SAFETY RECALL

Volvo Trucks North America

Date	Number	Release	Page
06. 2024	RVXX2402	04	1 (5)

**Steering Draglink
VN, VNE, VHD**

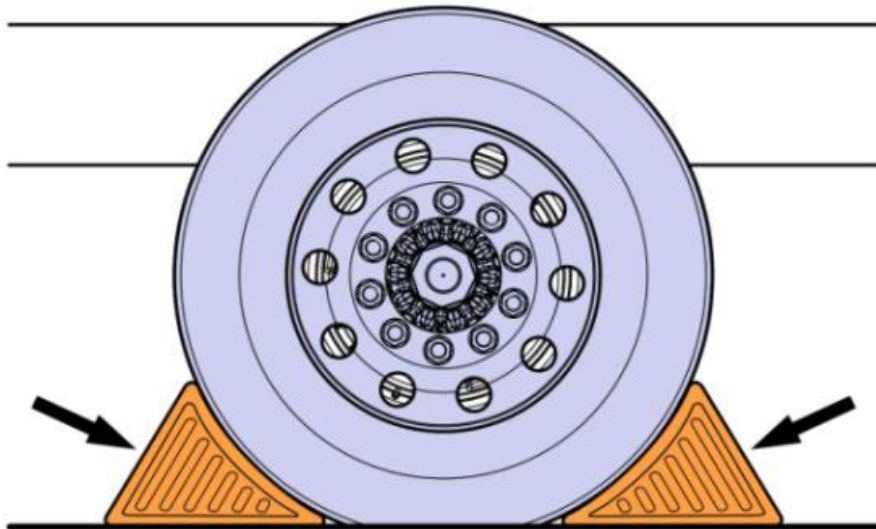
IMPORTANT NOTE:

- Replacement parts within suspect build date:
 - You may receive a replacement part that is within the suspect build date. Ensure this part has a QC Approval tag attached.
 - If there is no tag, do not install. Contact campaign@volvo.com
- Replacement parts outside suspect build date:
 - There will be no tag on these parts.
 - OK to install following normal procedures.

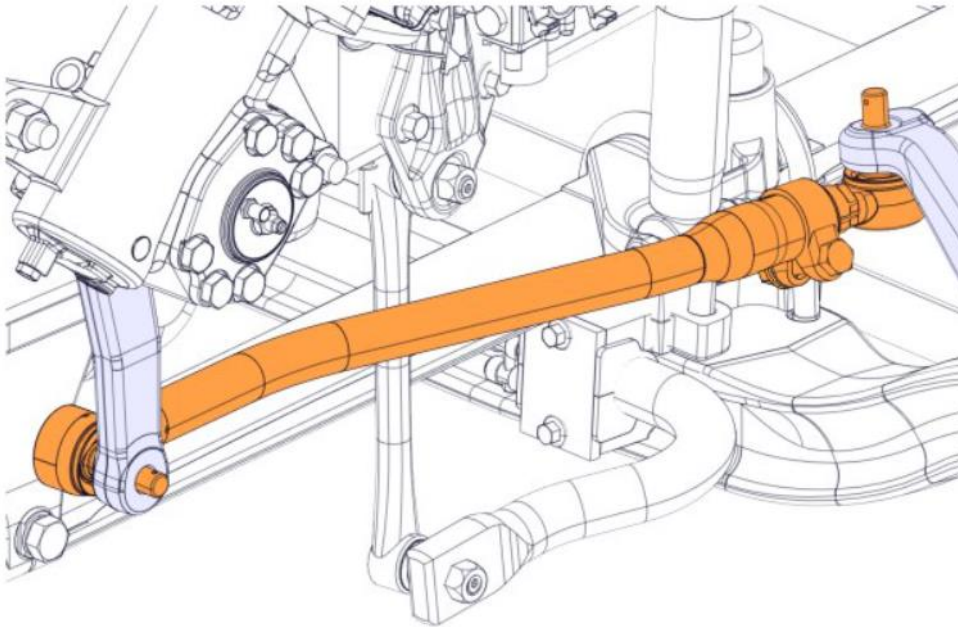
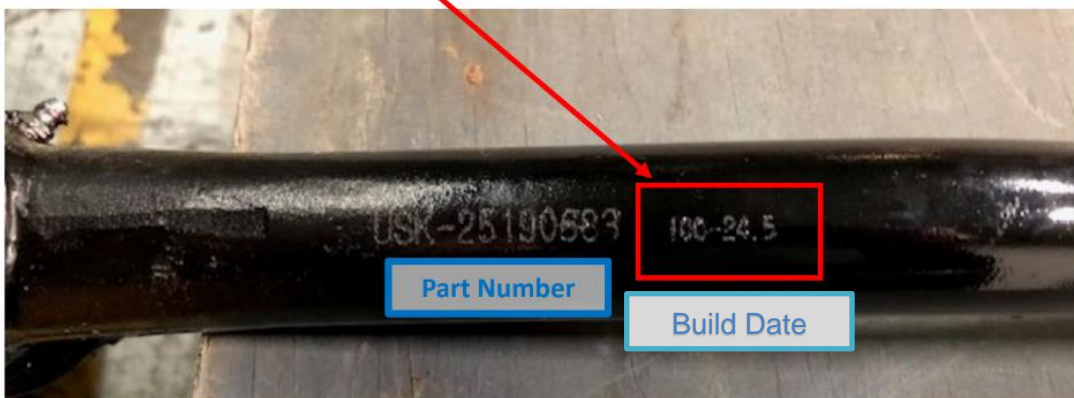
5. Identify the draglink assembly connecting the steering lever and the pitman arm.

NOTE: Some trucks may have dual draglinks depending on configuration.
